Addendum No. 05

Subject: Bid Questions for Phase 1 Site Improvements at Central High School
B-025C of 2017/18 General Construction and B-026C of 2017/18 Electrical Construction

Location: Central High School

Figure 12.04

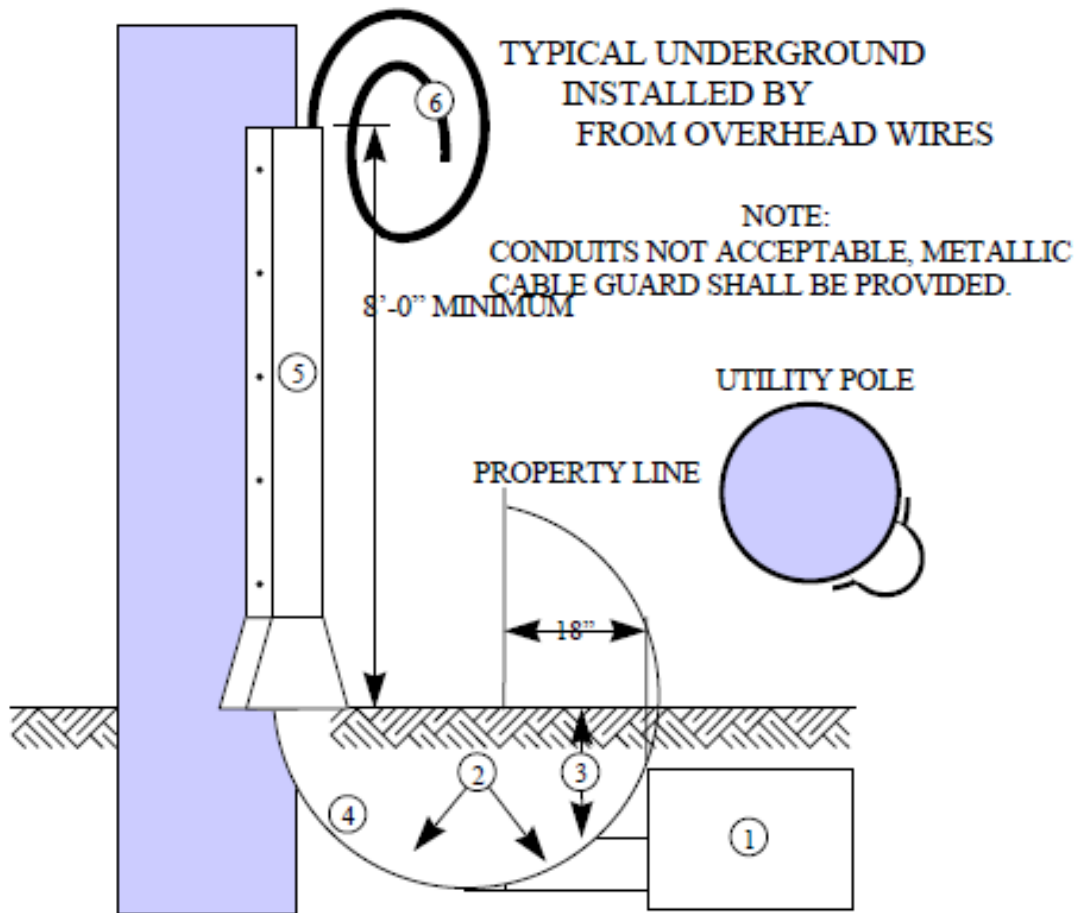
3. Can you provide a sketch to detail how we stub up for 5” ducts at the existing PECO utility pole?

Response: Refer to attached Peco Pole Illustration from the PECO Blue Book.

4 SECTION AT COAL TUNNEL EXTENSION - SOUTH
1/4" = 1'-0"

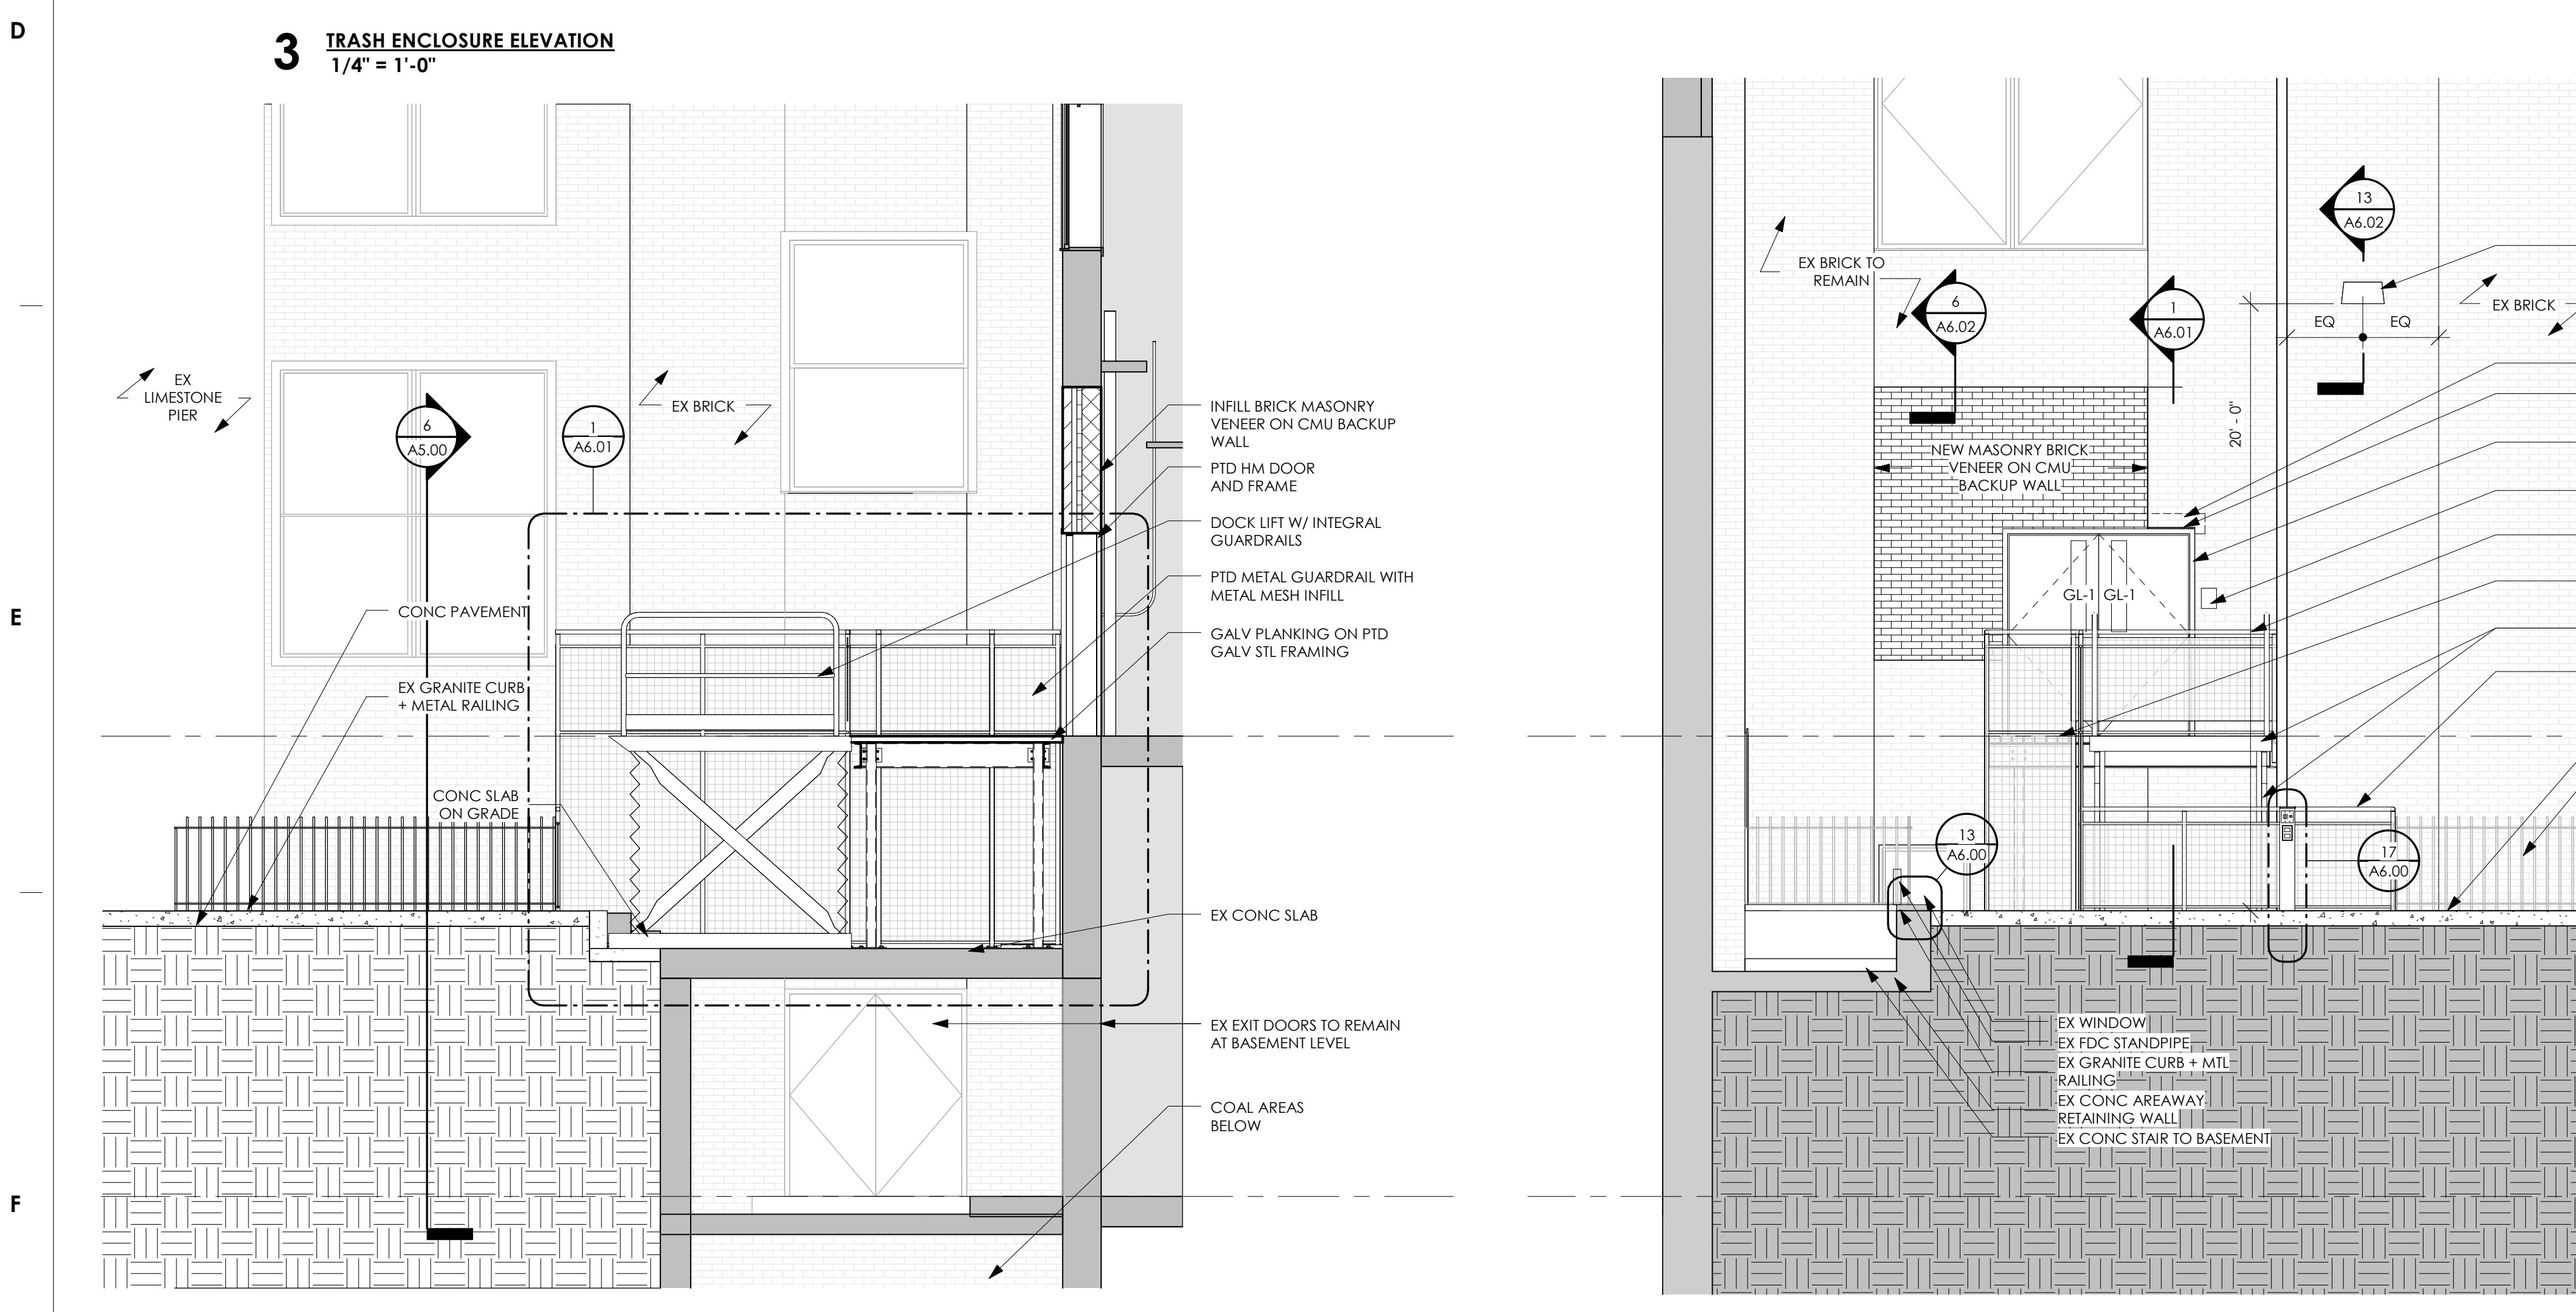
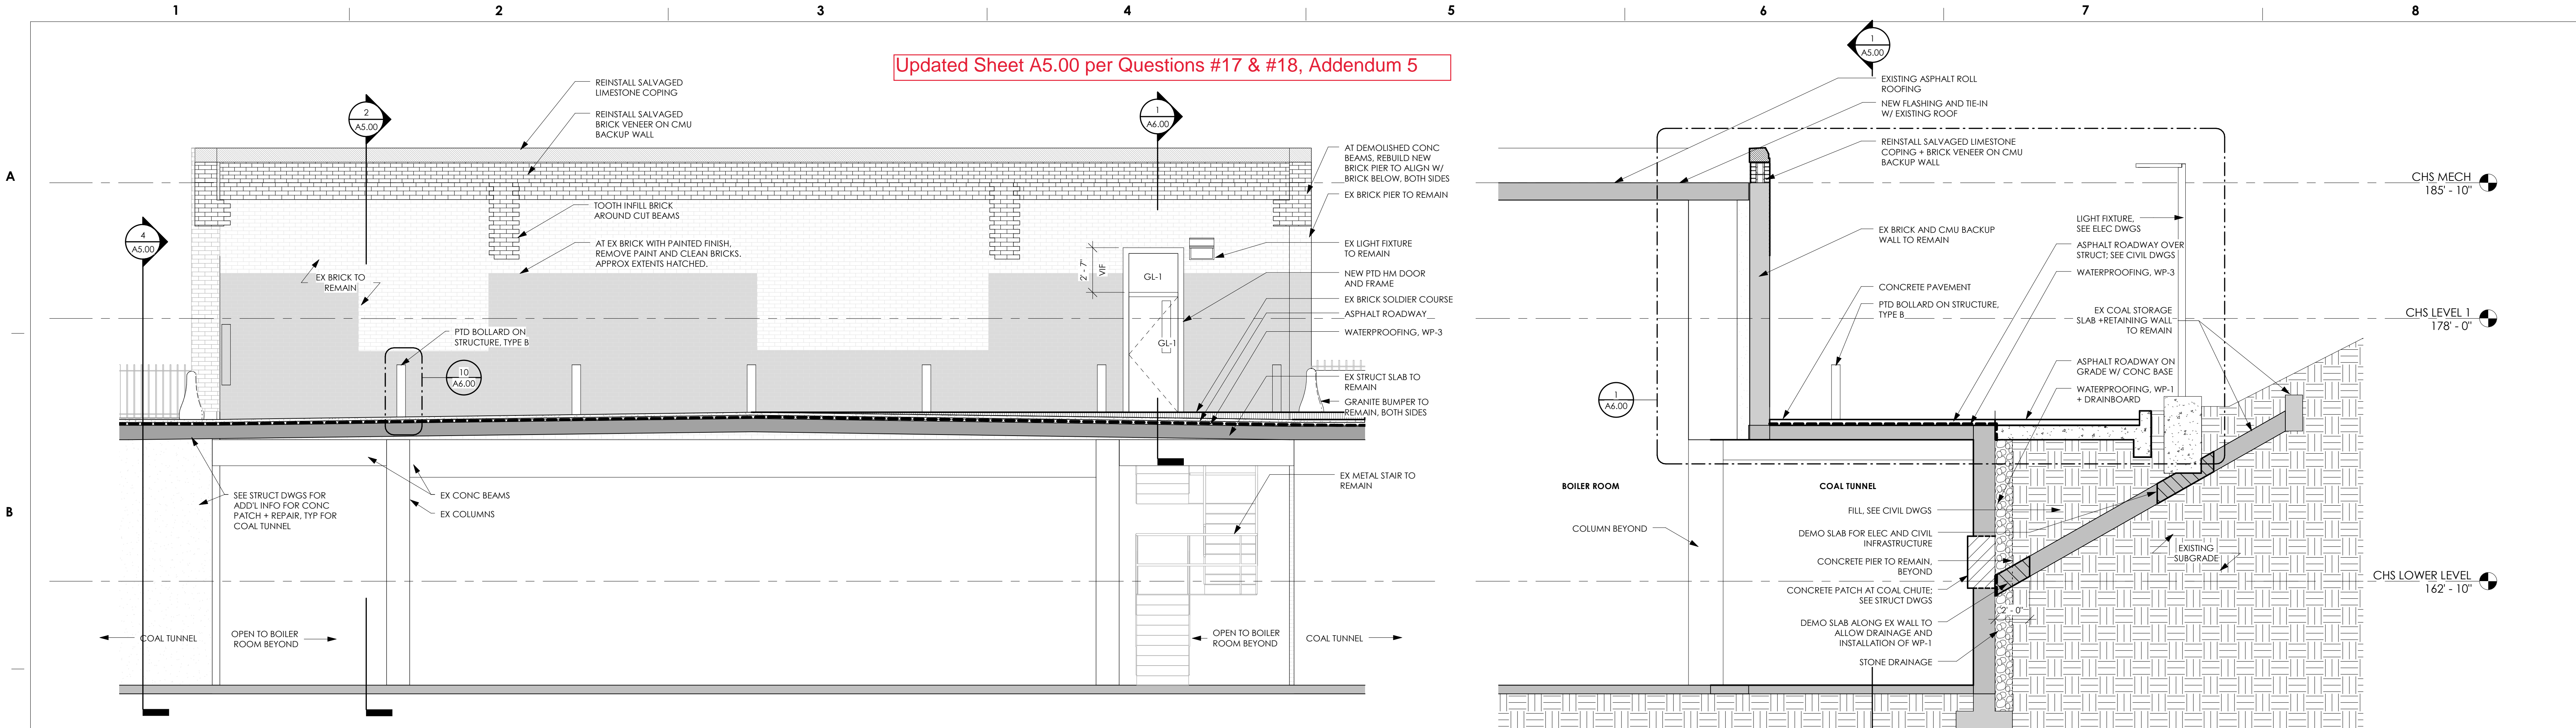
17. WP-3 Cold Fluid Applied Waterproofing on the lid of the tunnel. Detail 4/A5.00 has WP-1 on the lid of the tunnel is this a mistake? Detail 10/A6.00 has WP-1 under penetrations on the lid. Is this a mistake?

18. WP-1 Bentonite Waterproofing on Vertical Walls and columns. Is the bentonite waterproofing to be installed on all vertical wall surfaces all sides? Detail 4/A5.00 shows only one side.

Response: See attached revised sheets A5.00, A6.00 with corrected notes. WP-3 shall be applied to topside of tunnel, including at bollards on structure. WP-1 shall be applied to vertical faces of tunnel wall to remain.

Response: WP-1 shall be applied on vertical walls and columns along West side of tunnel, where coal chutes are being removed. Along North, South, and East sides, extend new waterproofing 1' below grade.

Updated Sheet A5.00 per Questions #17 & #18, Addendum 5
